State of Colorado
Oil and Gas Conservation Commission

EARTHEN PIT REPORT/PERMIT

Conditions of Approval – January 4, 2012

Grand Valley Pit # 1; Facility ID: 426954

POND #1 (AS-BUILT DRAWING)

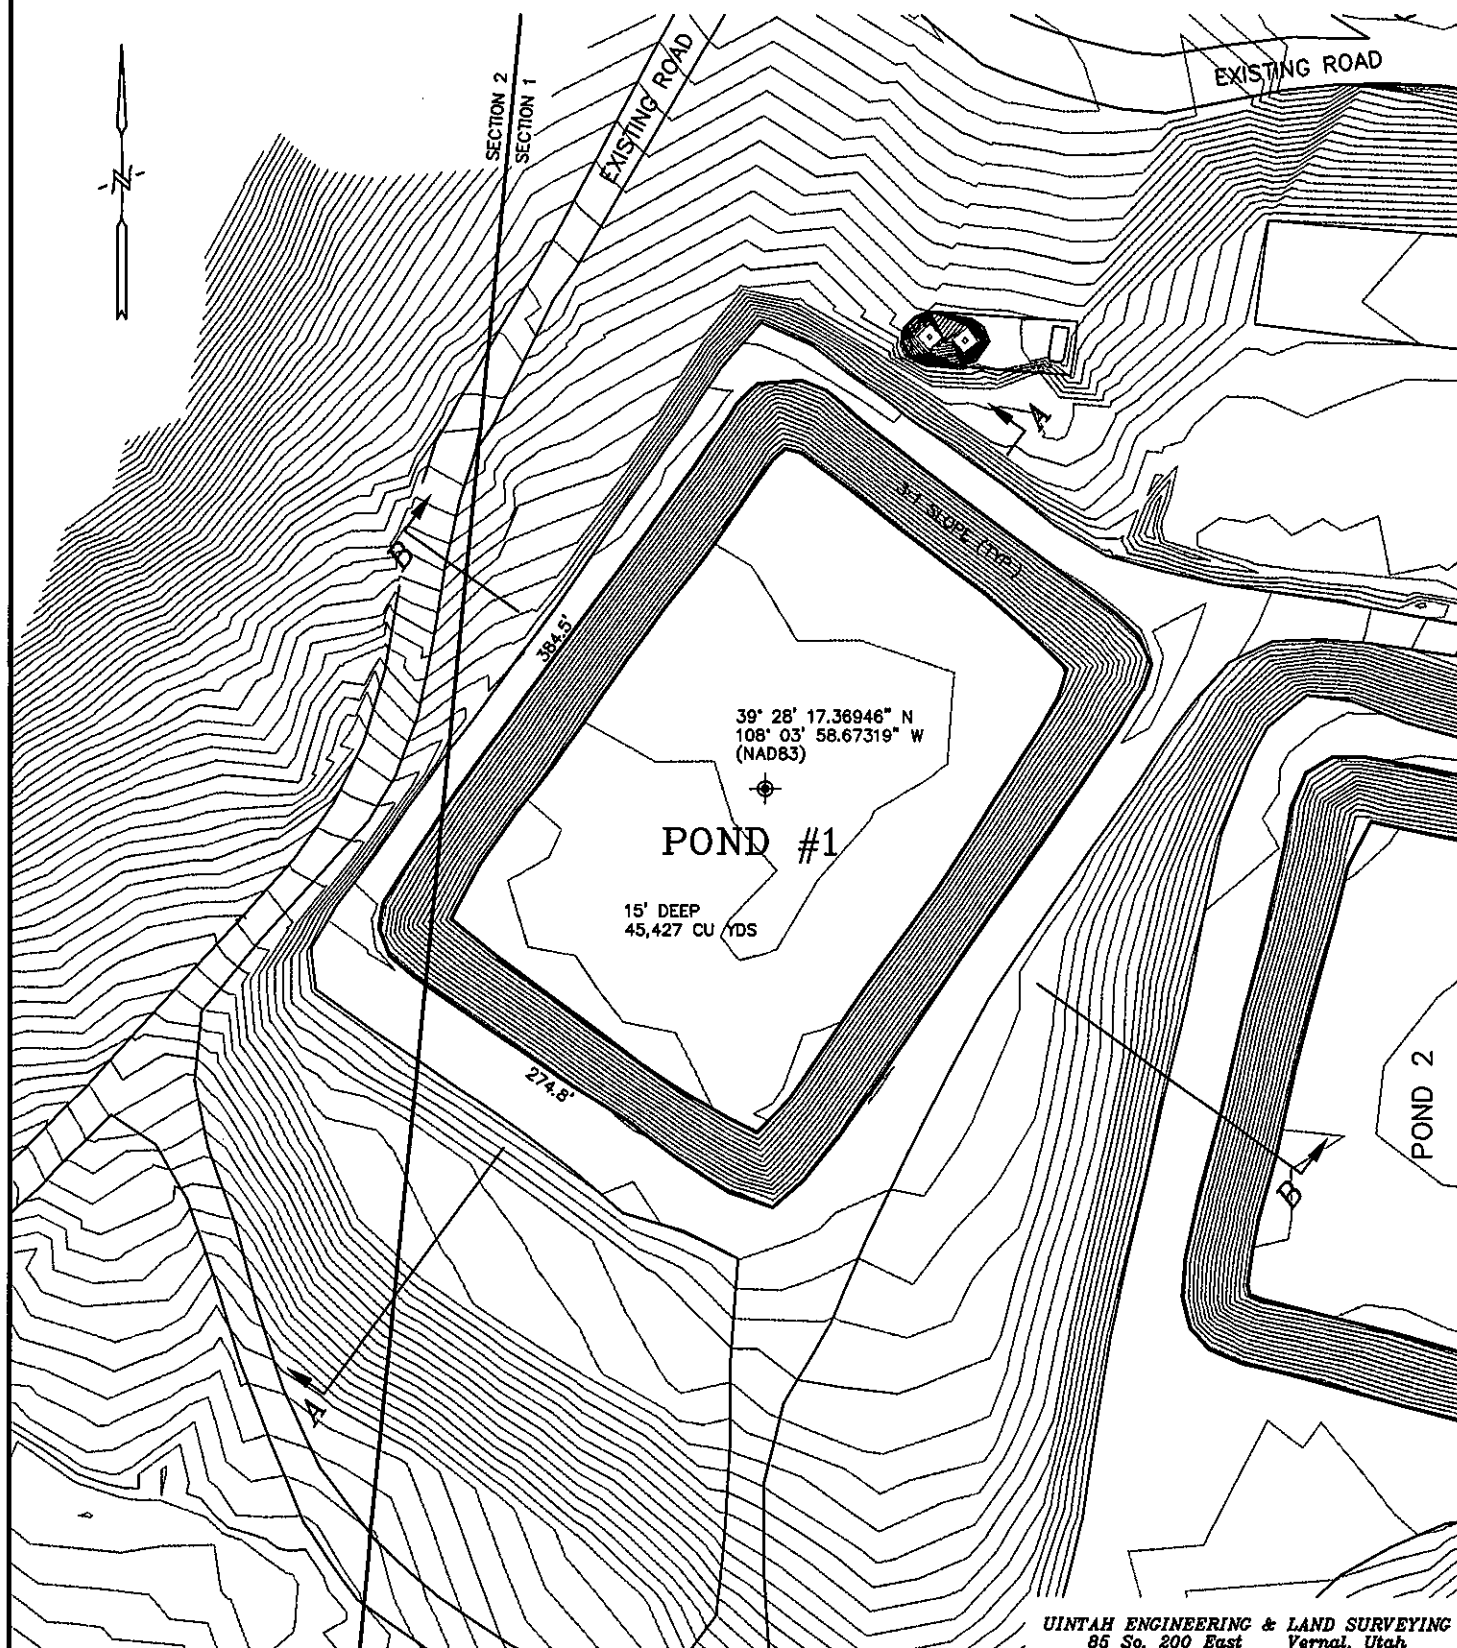
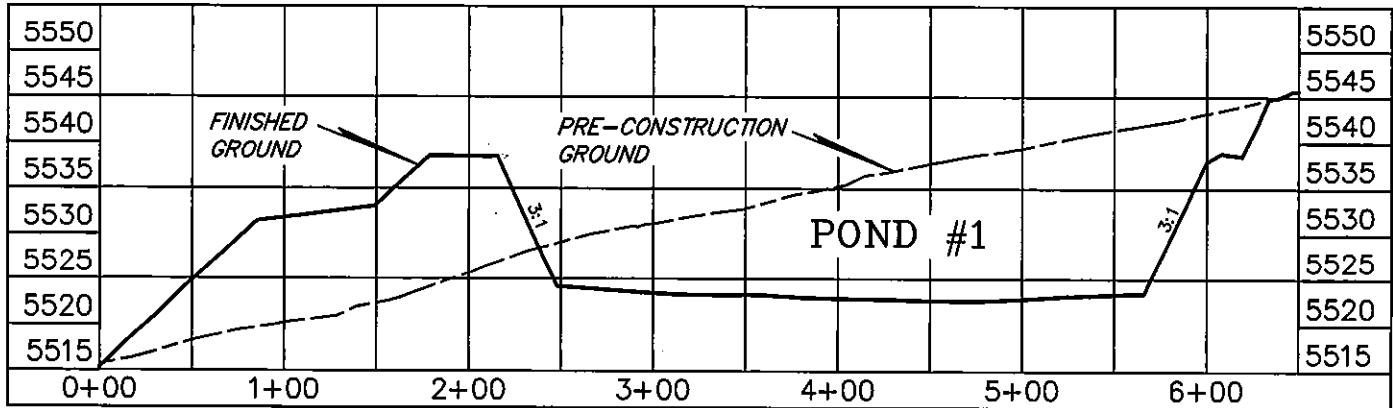
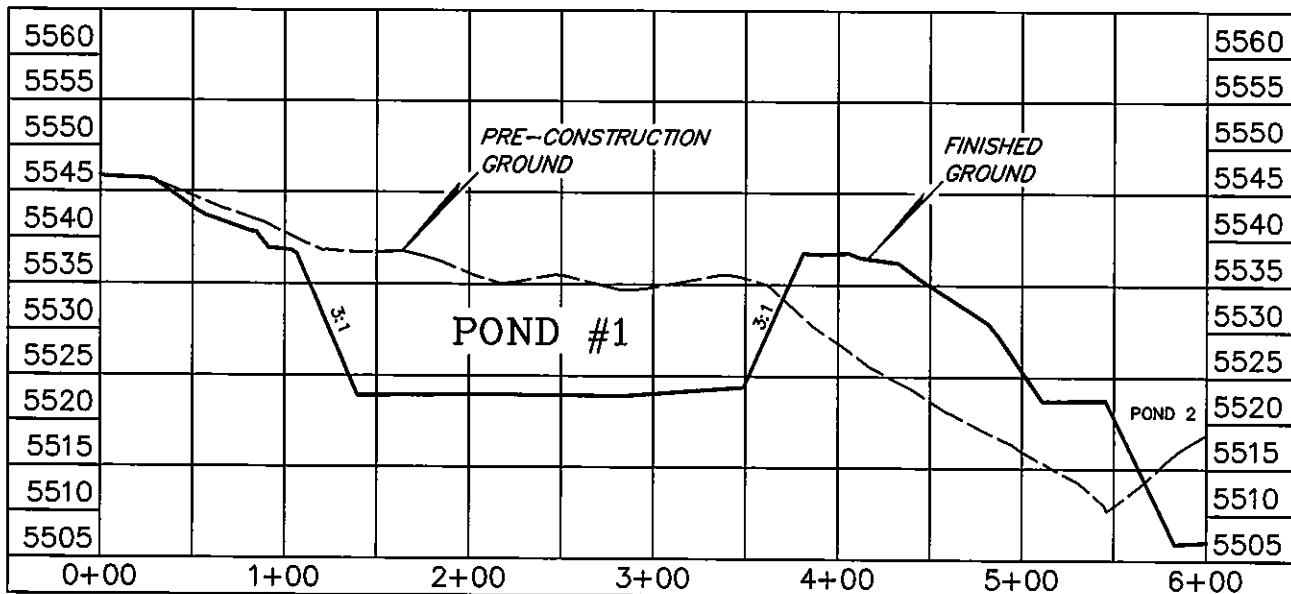
Pit is constructed in fill. Provide a Professional Engineer (P.E.) stamped review of the as-built construction of the pit and integrity of the pit.

Provide the as-built construction details.
